GRAVELY Service Bulletin

Product Family: Pro-Turn 400 Series Mowers

Subject: Air Ride Seat 04383700

Dealer Action: Inspect and Correct as Necessary

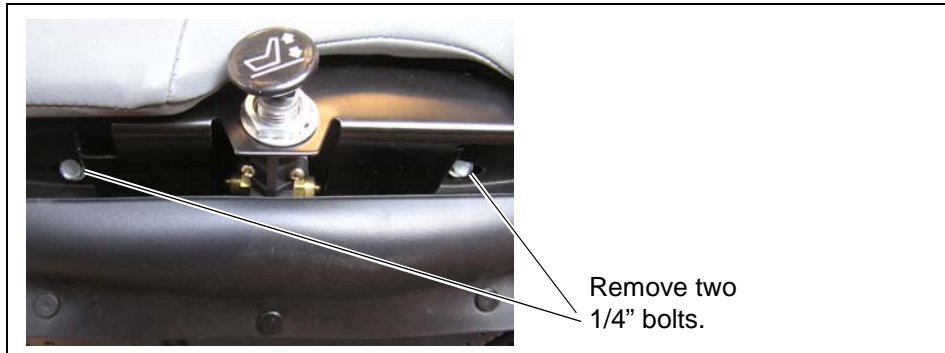
1. Check the Milsko serial number of the seat on an affected unit. If the serial number of the seat is above 53-798950 then it is not necessary to do any further inspection.

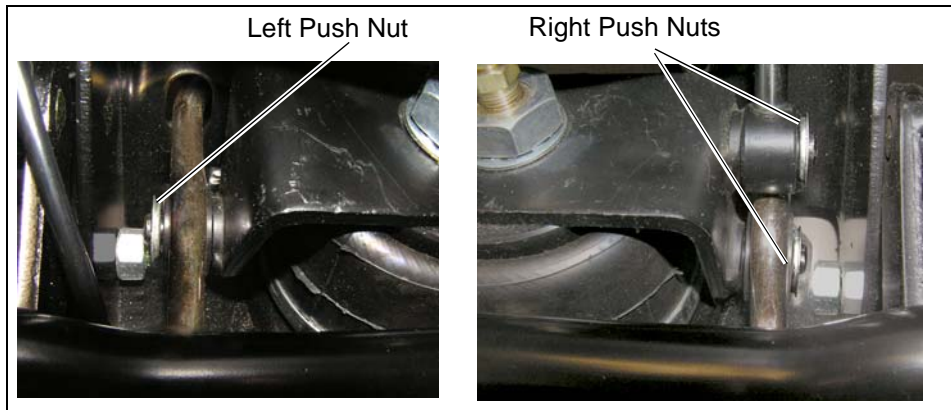
2. If the Milsco serial number is 53-798950 or below, remove the lower seat cushion. Remove two 1/4-20 bolts under the front of the cushion. Pull cushion up and forward to remove.

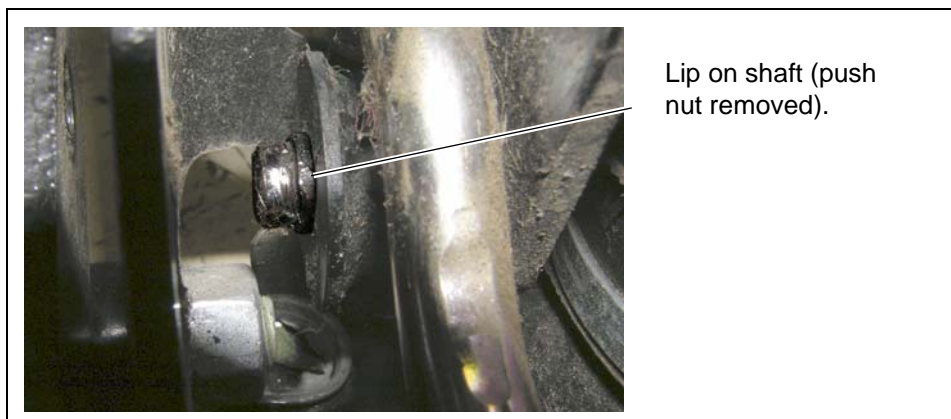
3. Inspect the three push nuts holding the arms to the air-spring saddle. One is found on the left side and two are on the right side.

4. If the push nuts are not seated properly, use a forked pry bar or screw driver to push the nut into the correct position.
5. Properly seated, the push nut will be pressed against the lip on the shaft. The following photograph shows the lip with the push nut removed.
